ALAMEDA COUNTY
HEALTH CARE SERVICES

RE: **Workplan for Preliminary Soil and Groundwater Investigation**
Former Sinclair Paint Site, 2040 San Pablo Av., Oakland CA 94612(Our site # 6548)

Report
Preliminary Soil and Groundwater Investigation
Former Sinclair Paint Site
2040 San Pablo Avenue
Oakland, California

Figure 1

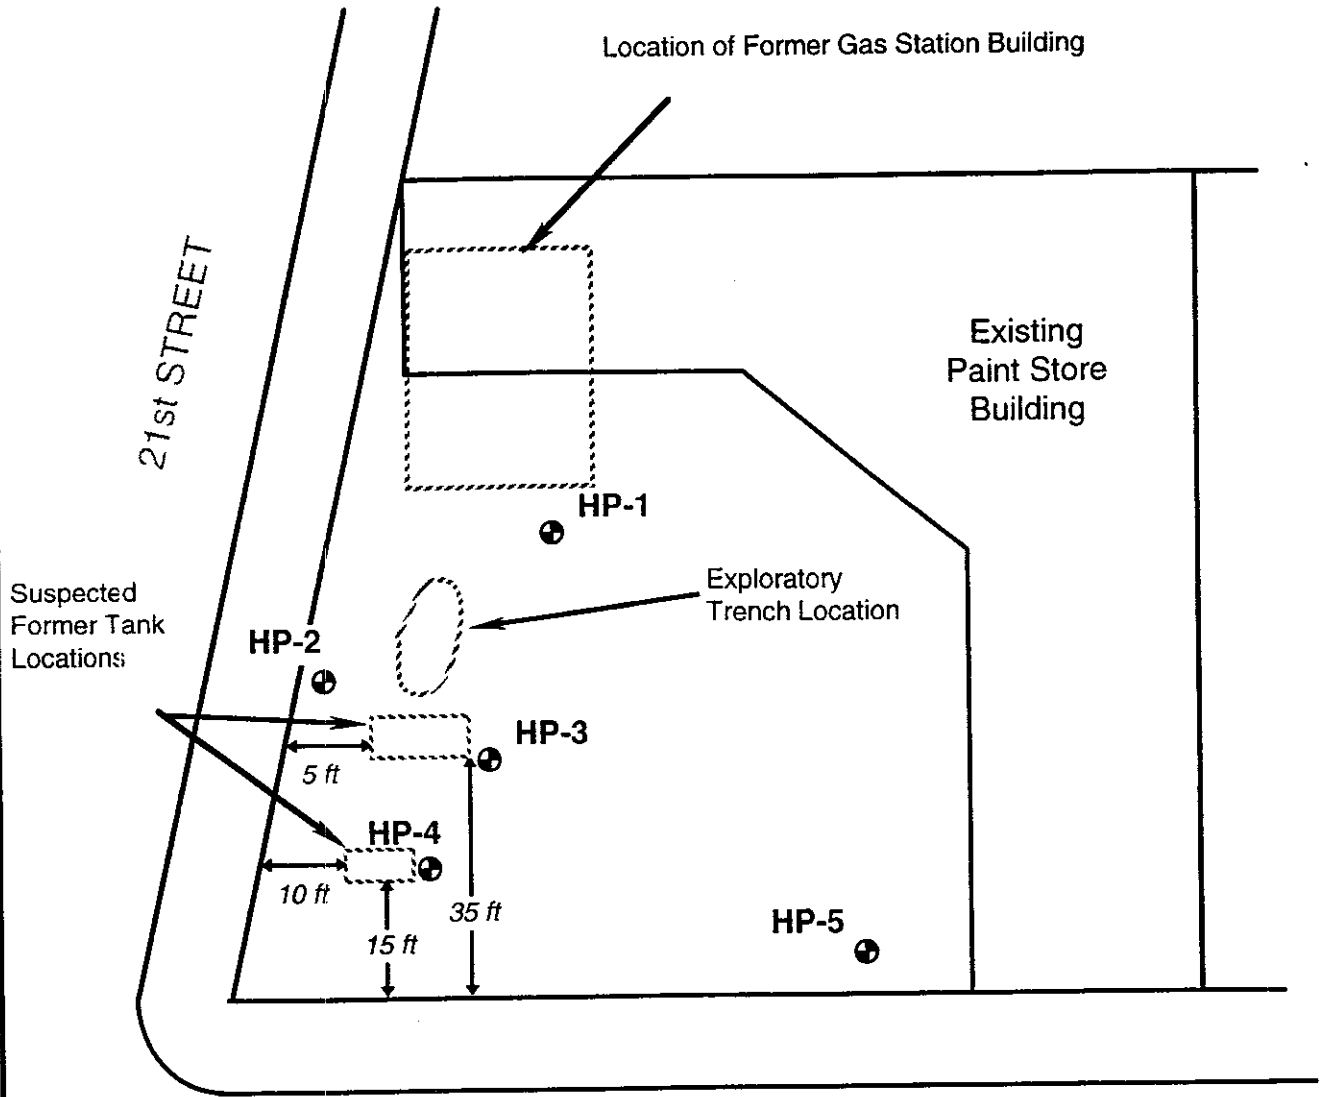
Owner has had a contractor investigate the site with a metal detector, narrowed down possible location to those shown in site plan. (PS) (asked that this work be described in the preliminary site assessment report. 10/17/97
